Conservation Board Meeting Public Notice

Conservation Board Meeting Minutes

Conservation Board Meeting Minutes

1. **ZP-23-545; 245 Appletree Point Rd (WRL, Ward 4) Ramsay Gourd**
Demolish existing residence and construct a new residence in the same footprint

L100

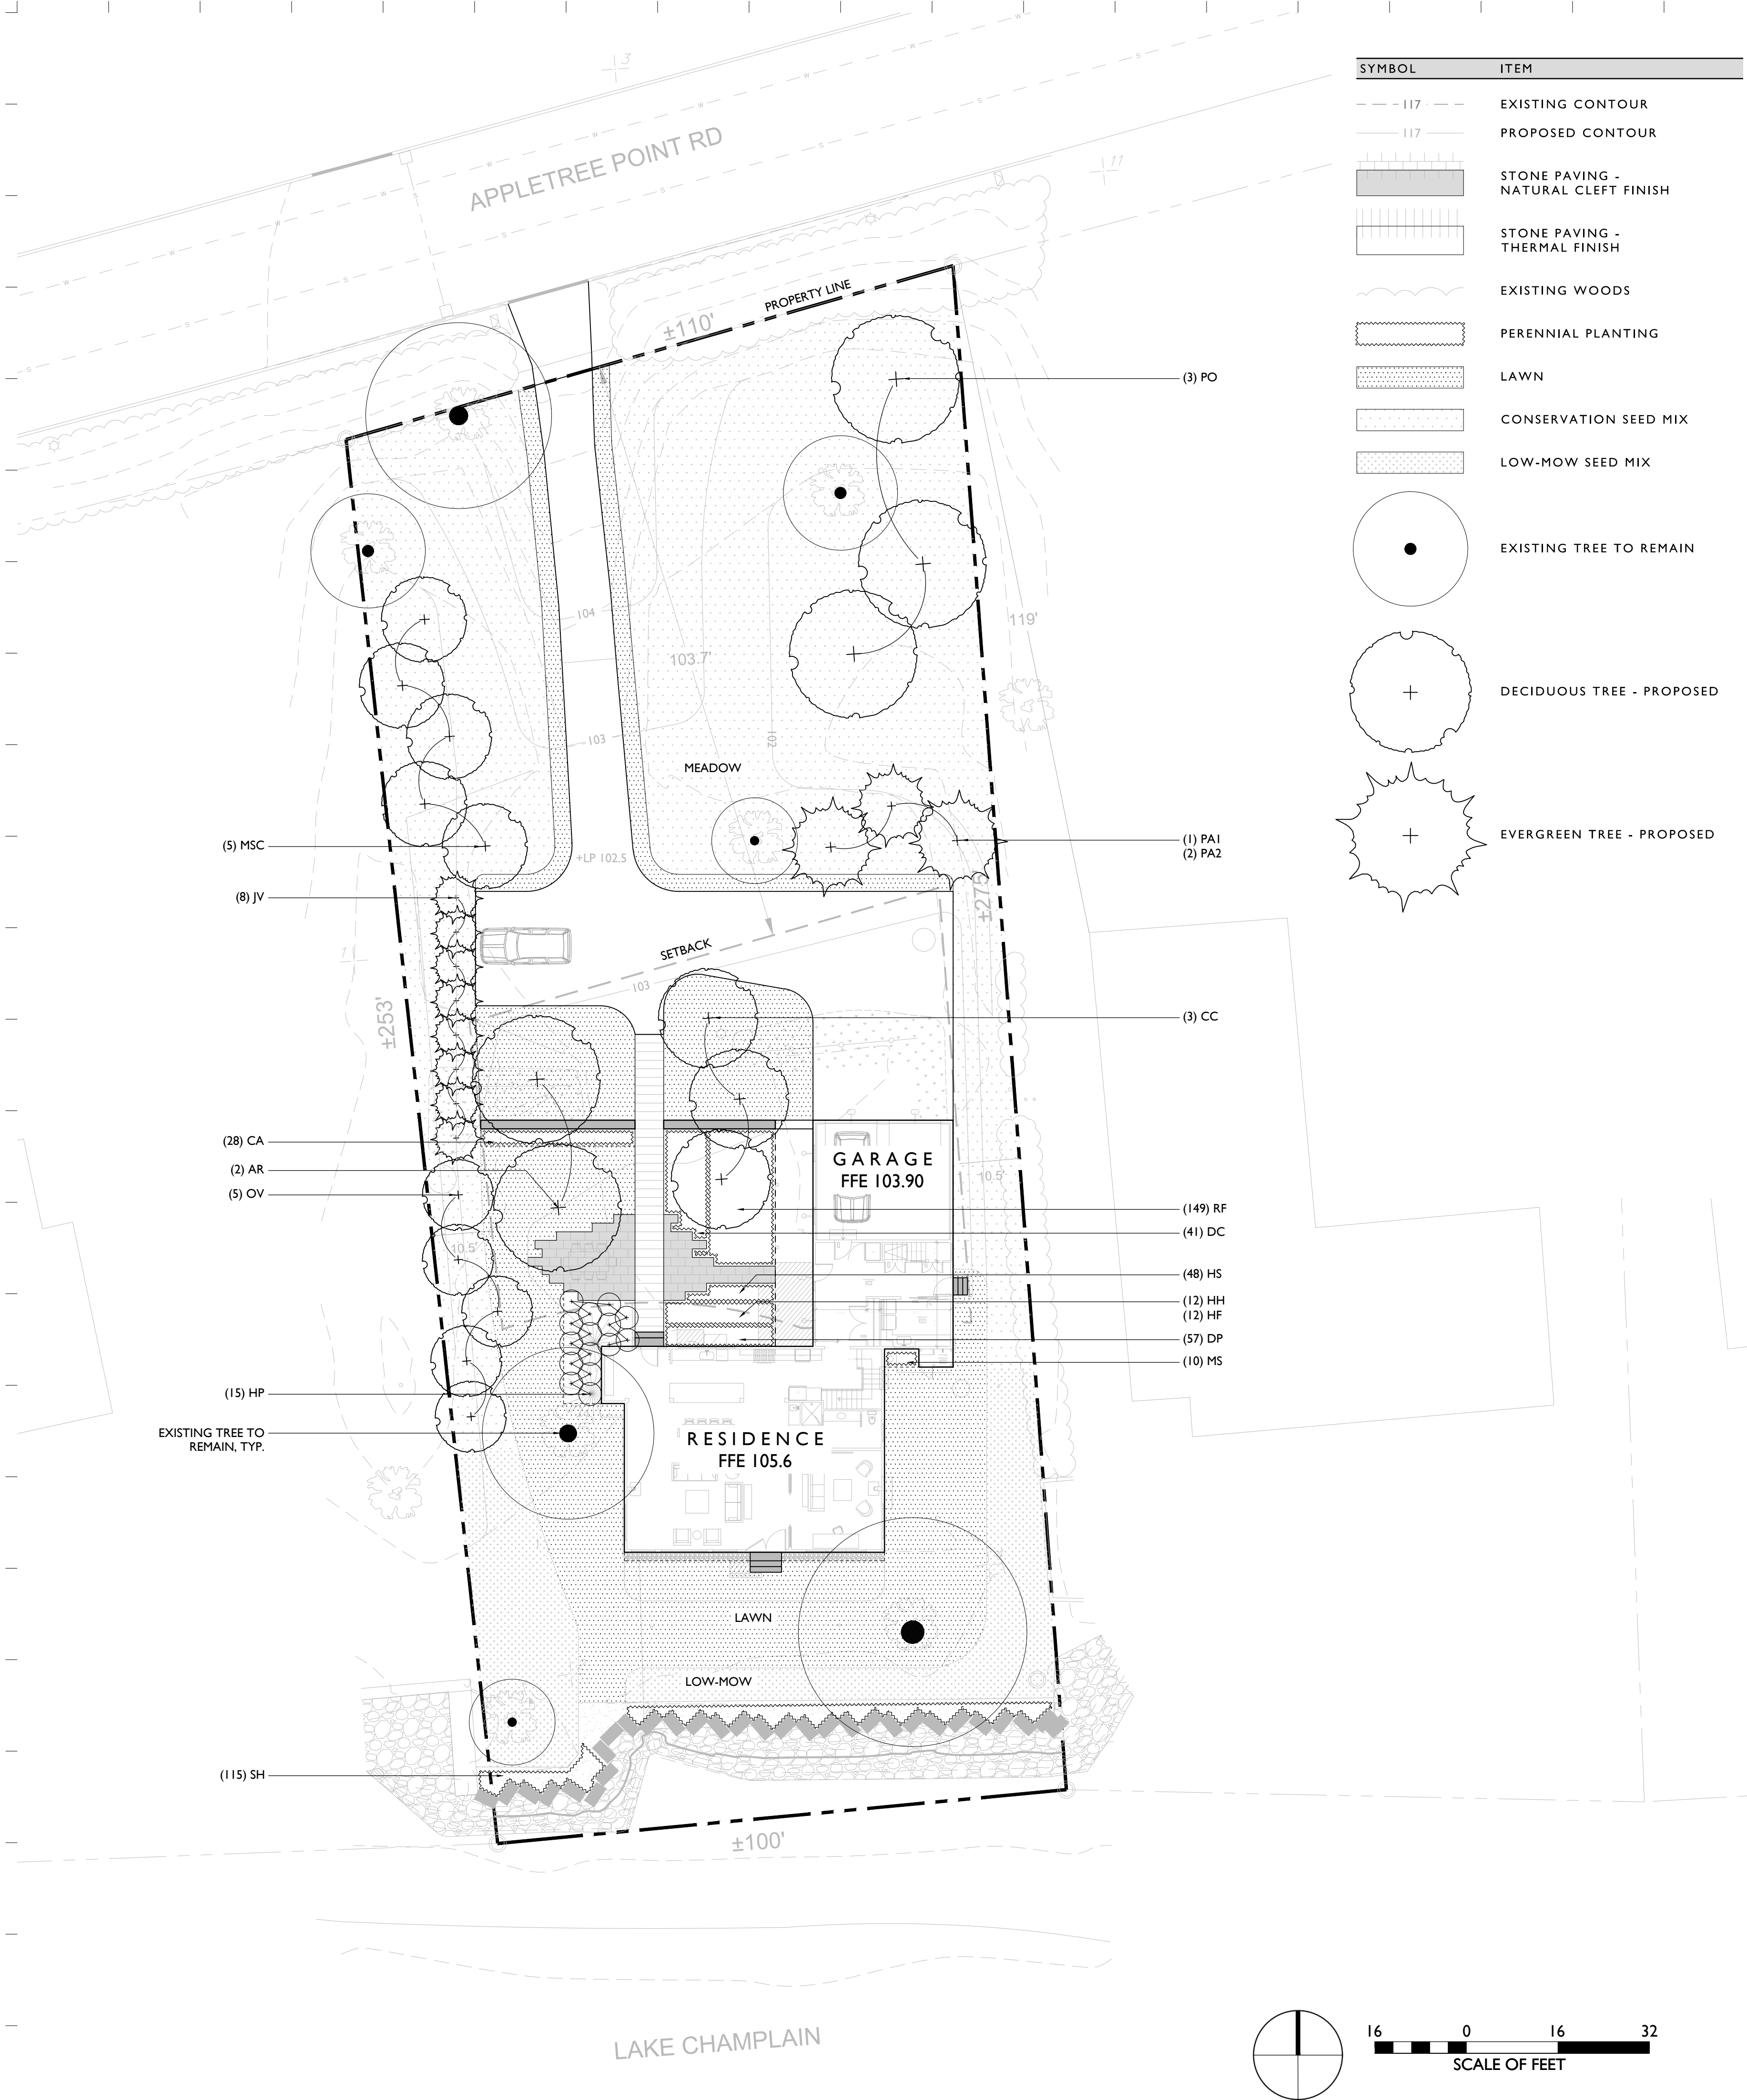
RC, can you tell us about existing elevation info? Rem Kielman, the residence is at FFE of 104.1'. That will be raised 18" to 105.6'. The garage sits a little lower at 103' – being raised to 103.9'. Seth Goddard said there's not much change in topography across the site.

ZR can you tell us about the trees you're retaining versus removing? Rem Kielman, we have two cedar trees that are about 6" away from the foundation. Those will be removed. There are 3 ash trees onsite. One close to the rip rap, one south of some shrubs, and one sitting in the NE memo. The owners are working with an arborist to try to save them as long as possible. Some nurse trees are proposed in the NE corner to grow up around the ash tree there.

Rain Garden/Bioretention Planting Soil Bed Detail

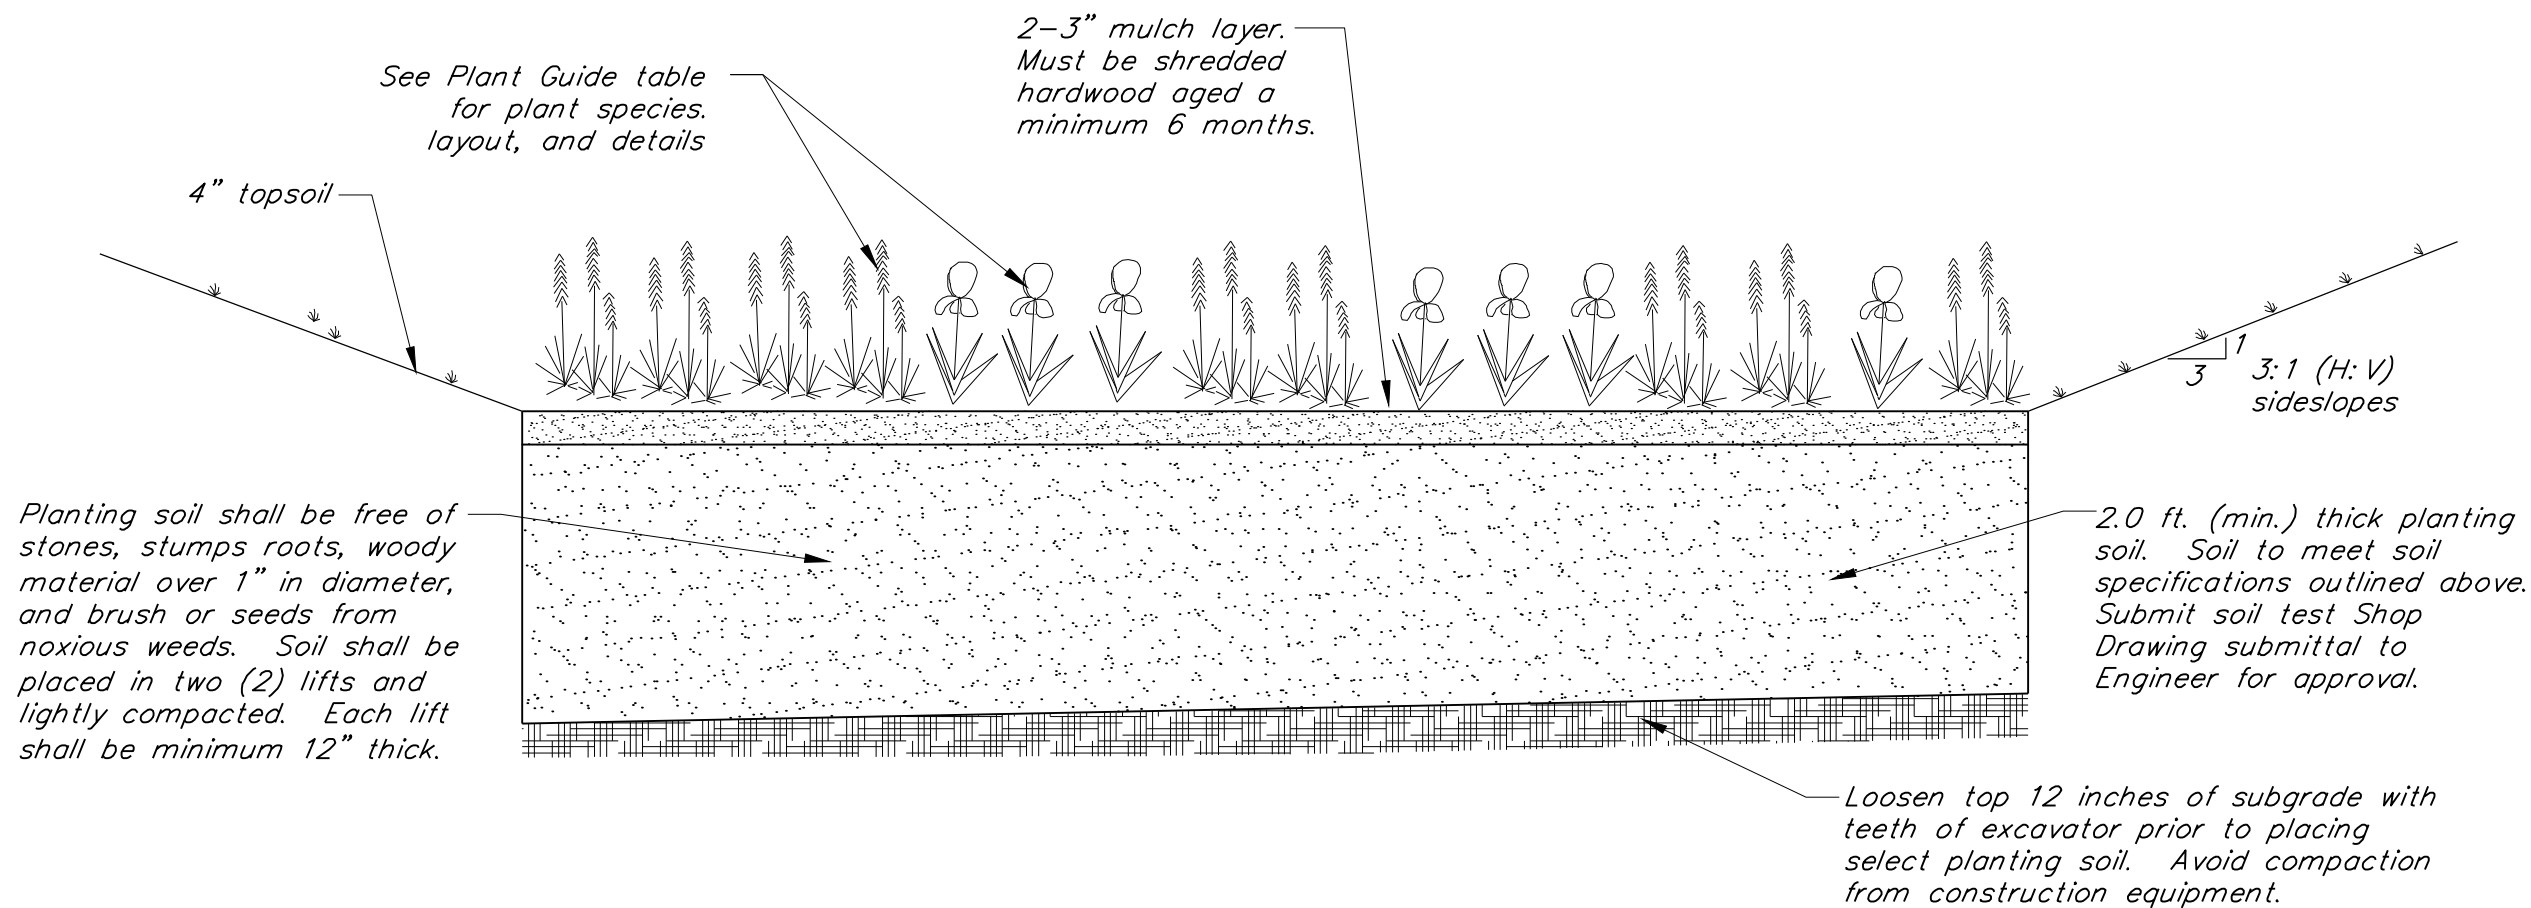
MW, about the rain garden, is it near any neighboring buildings that may be impacted by overflow? Seth Goddard, the two neighboring buildings are elevated higher than this site. MW, has there been any analysis for infiltration? Seth Goddard, its not designed for infiltration. It will overflow with larger storm events. MW, how did you determine the boundaries of the low mow zone? Rem Kielman, the low mow zone basically blends into the proposed conservation mix plantings. The area relates to the area of the redevelopment.
